Subject: Crazy Horse Canyon Switching Station Project— Review of Minor Project Modification #11

Re: **Crazy Horse Canyon Switching Station Project
Request for Minor Project Modification #11 – Installation of Barbed-wire Fence
along Property Line and Landscaping outside Approved Work Area**

Figure 1 - Minor Project Modification #11
Property Line and Landscaping Work Areas
 Crazy Horse Canyon Switching Station Project

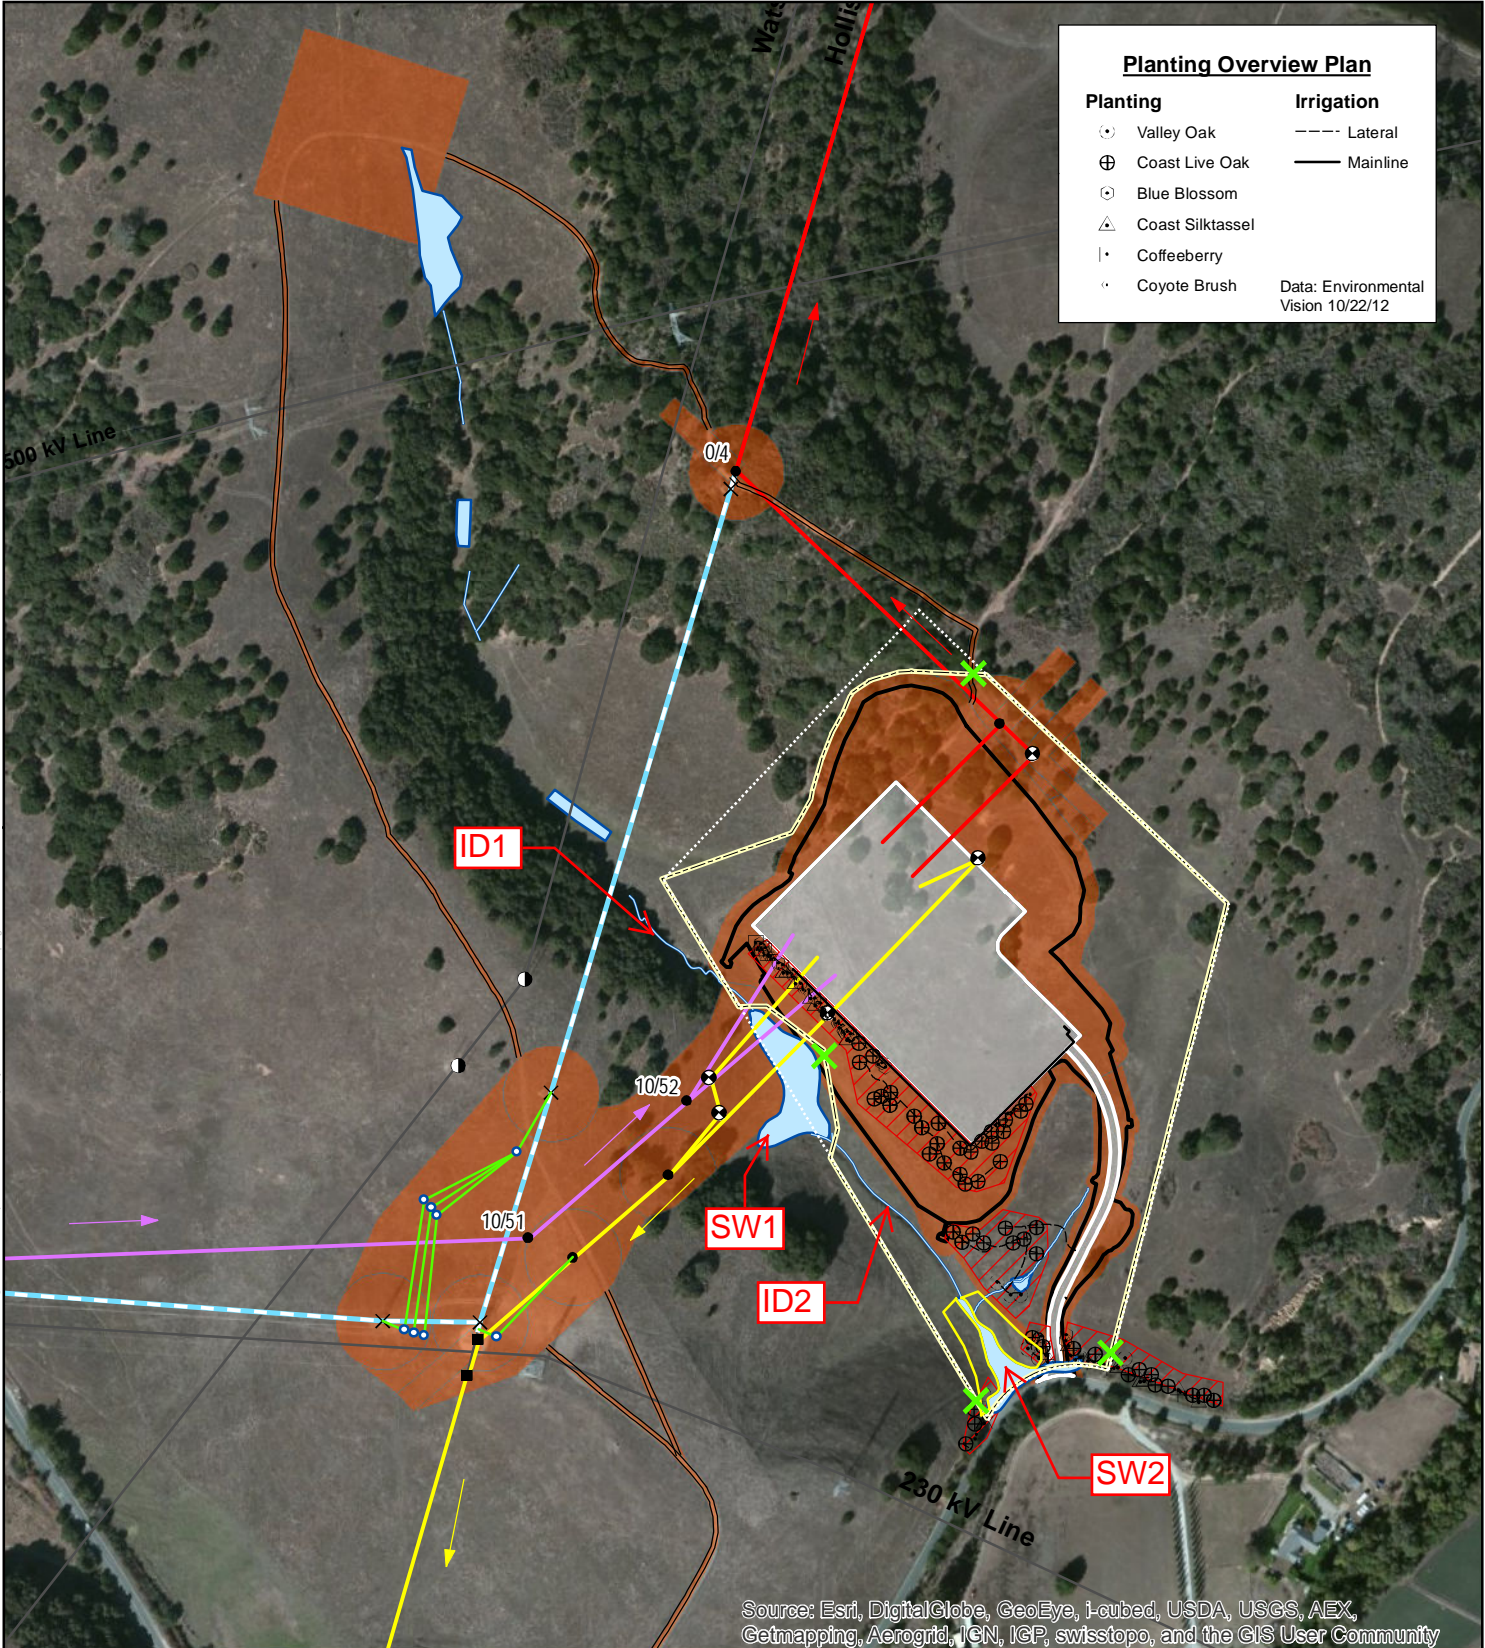
installed. Two gates would be located at the northeast and southeast corners of the property line on either side of SW2. One gate would be located east of SW1, and one would be located at the ranching road northeast of the property line. The proposed fence line, gate locations, and property boundary are shown on the attached figure.

Less than significant impact. The proposed fence would be installed along the east side of SW1, the west side of SW2, and span Intermittent Drainages (ID) 1 and 2, located to the north and south of SW2 (shown on the attached figure). The fence would not impede the function of the drainages, and no fence posts or other materials would be installed in the water features. Trees and plants installed at the proposed landscaping work areas would not be placed in jurisdictional water features. Construction within and adjacent to jurisdictional water features was evaluated in the IS/MND and found to be less than significant with mitigation. Impacts to jurisdictional features were permitted through the Regional Water Quality Control Board, Central Coast Region 401 Permit, the United States Army Corps of Engineers 404 Permit, and CDFW 1602 Permit. The proposed actions would not involve new or greater impacts to hydrology or water quality than those analyzed in the IS/MND.

The property line crosses seasonal wetland SW1 at an angle that is approximately 150 feet in length (see Figure 1), as well as a jurisdictional drainage northwest and again southeast of SW1. PG&E plans to install the fence east of SW1, deviating from the property line to avoid impacts to SW1. In addition, the barbed-wire fence installed by PG&E will tie into the existing fence along San Juan Grade Road for a length of 293 feet, which runs through seasonal wetland SW2 for a length of 223 feet; therefore, no new fence will be installed near or through seasonal wetland SW2. Because both SW1 and SW2 will be avoided, no fence posts will be installed in wetlands or the drainages. In addition, the barbed-wire fence will be placed inside the property line along the northwest side of the property to avoid impacts to oak woodland.

Some of the areas where landscaping is to be installed are outside of approved construction work areas and were not previously subject to a pedestrian survey for cultural resources (see Figure 1). Therefore, an updated records search and additional pedestrian survey was performed to determine if implementation of the Landscape Plan would have the potential to impact cultural resources. Attached is an addendum to the Cultural Resources Investigation for the Crazy Horse Canyon Switching Station Project, prepared by Garcia and Associates and dated May 21, 2014, documenting that no cultural resources were observed, no historical resources were identified, and no additional mitigation measures are proposed.
